**TECHNICAL BULLETIN**  
**Bell Helicopter** **TEXTRON**

No. 407-01-34

**MODEL AFFECTED:** 407

**SUBJECT:** **PYLON SIDE BEAMS 407-010-201-105 AND 407-010-203-105, INSTRUCTION FOR RETURNING TO SERVICE.**

Figure 1. Pylon Side Beams (P/N 407-010-201-105/407-010-203-105) Inspection  
(Sheet 1 of 2)

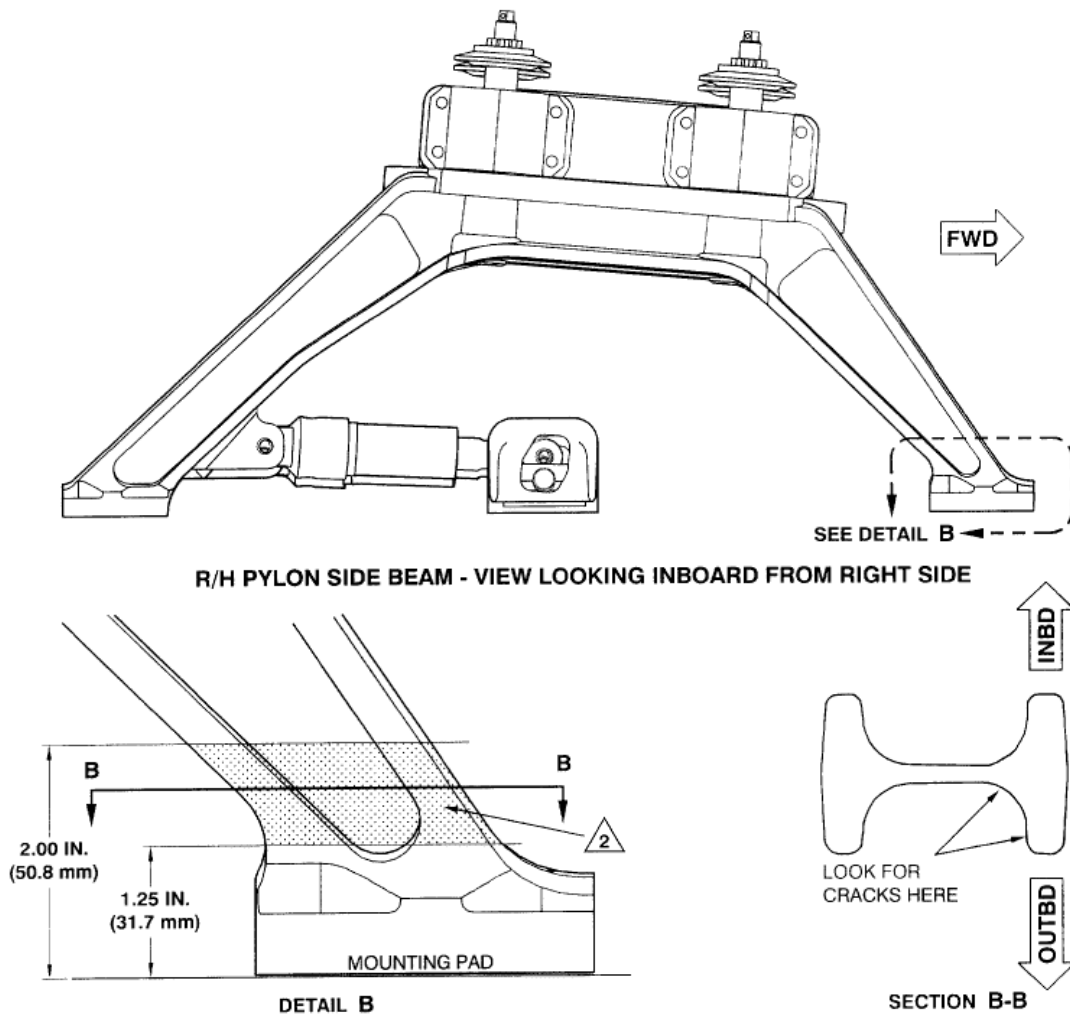
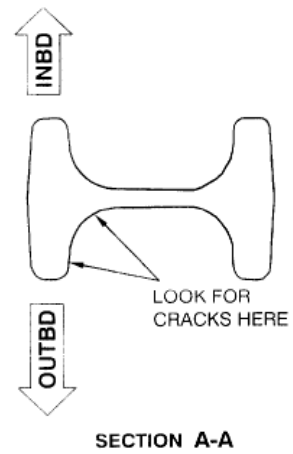
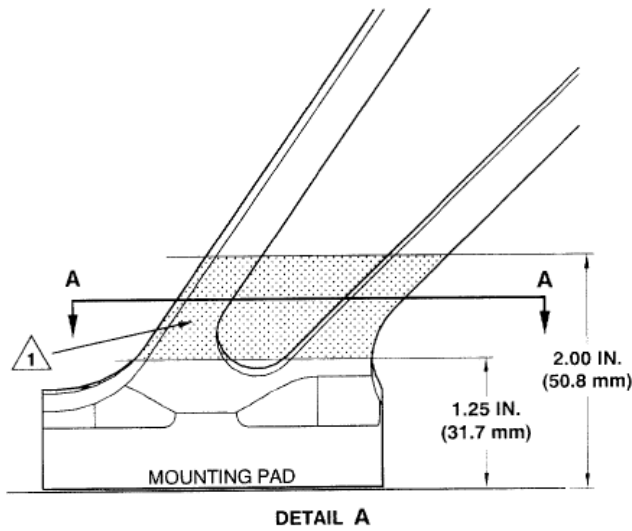
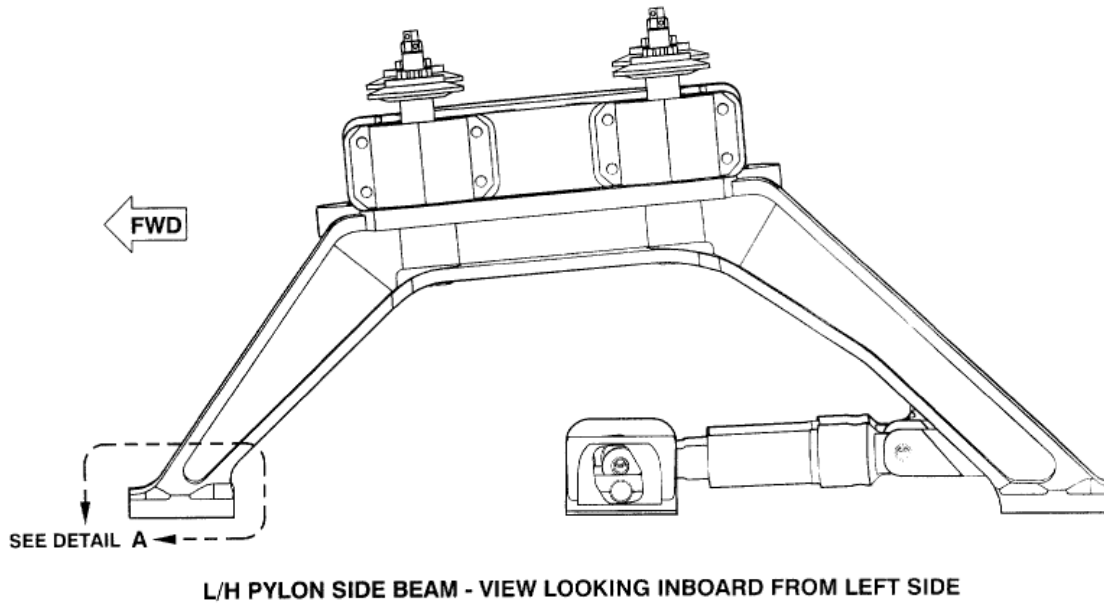
1. Remove paint and primer mechanically (BHT-ALL-SPM, Chapter 3) or chemically (BHT-ALL-SPM, Chapter 4).
2. Inspect the shaded areas with Fluorescent Penetrant (Figure 1, Detail A and B).
3. Apply Primer (C-204) and topcoat (C-245) per Figure 2.
4. Revise the Component Historical Records to reflect the new retirement life of the side beams (BHT-407-MM-1, Chapter 4, Table 4-1).
5. Make an entry in the Helicopter and the Component Historical Records to show that this Technical Bulletin is completed.
6. Do the recurring inspection per Part III.

1 2 Inspect the upper outboard flange and flange/web area for cracks. Inspect the area between 1.25 inches (31.7 mm) and 2.0 inches (50.8 mm) above the mounting pad.

- 3. If a crack is found in a pylon side beam, replace before the next flight and contact Product Support Engineering at the following numbers:

Figure 2. Pylon Side Beam Painting

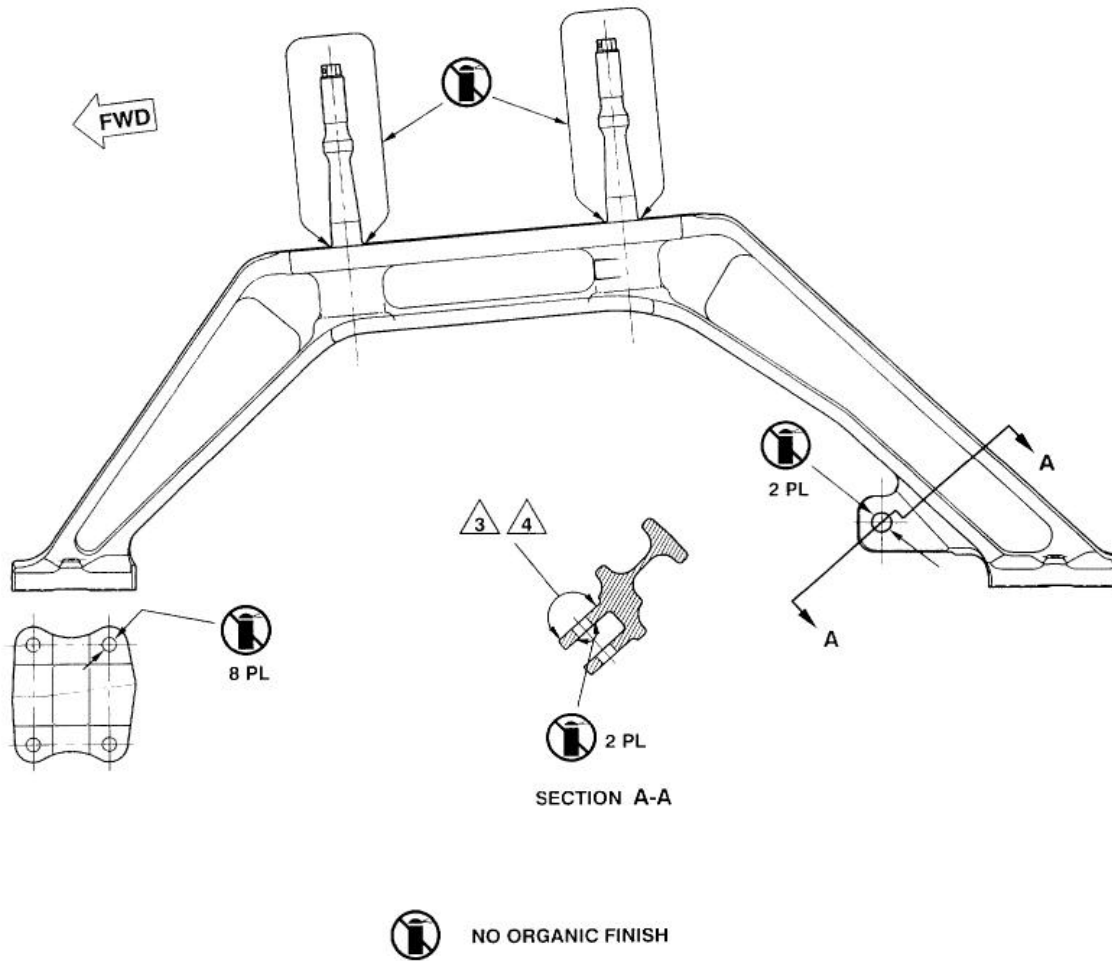
1. Apply Polyamide Epoxy primer MIL-P-23377 Ty I Class 3 or MIL-P-085582 Ty I Class 2 (C-204).
2. Apply topcoat MIL-C-85285 Ty I, FED-STD-595 color 16440 (light grey).
3. On beam (407-010-201) apply topcoat Imron Blue color No. 44543U to the left of the lug.
4. On beam (407-010-203) apply topcoat Imron White color No. 44916U to the right of the lug.
